1960 Corvette: Service Bulletin: Instrument Lens Cracking and Checking

Subject: Instrument Lens Cracking and Checking

Source: Chevrolet Technical Service Bulletin

Bulletin No: DR #448

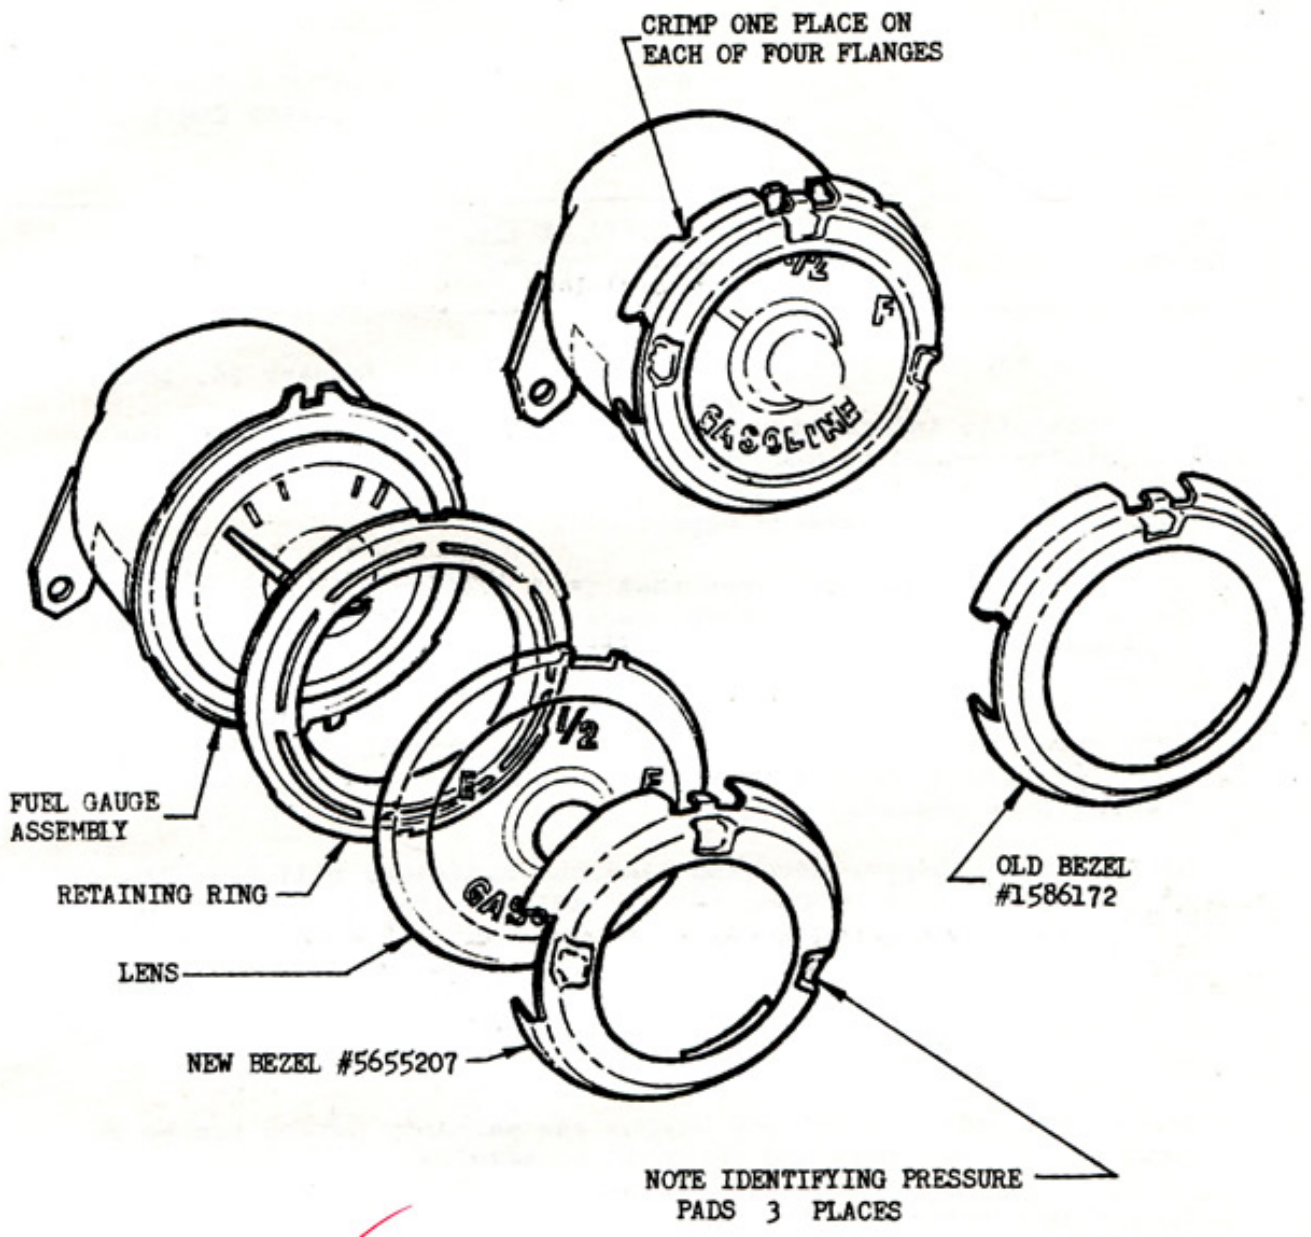
Field complaints of instrument lens cracking or checking on 1960 Passenger Cars have been traced to the means of lens retention in the various instruments.

A revised retaining bezel has been released for production and is available in Service Parts Stock. Three bezel pressure pads have been added and the number of crimps has been changed from eight to four as shown in the illustration.

When replacing a damaged lens, it will also be necessary to replace the first design bezel with the revised bezel listed below. no changes has been made to the individual fuel, temperature and tell-tale lenses.

5655207 -- Bezel

The new bezel should be crimped in one place on each of four flanges as shown in sketch after it is positioned over the lens. When reinstalling gauge

assembly to instrument panel, tighten mounting screws a minimum amount necessary to remove looseness and rattle of the lens. Do not overtighten!
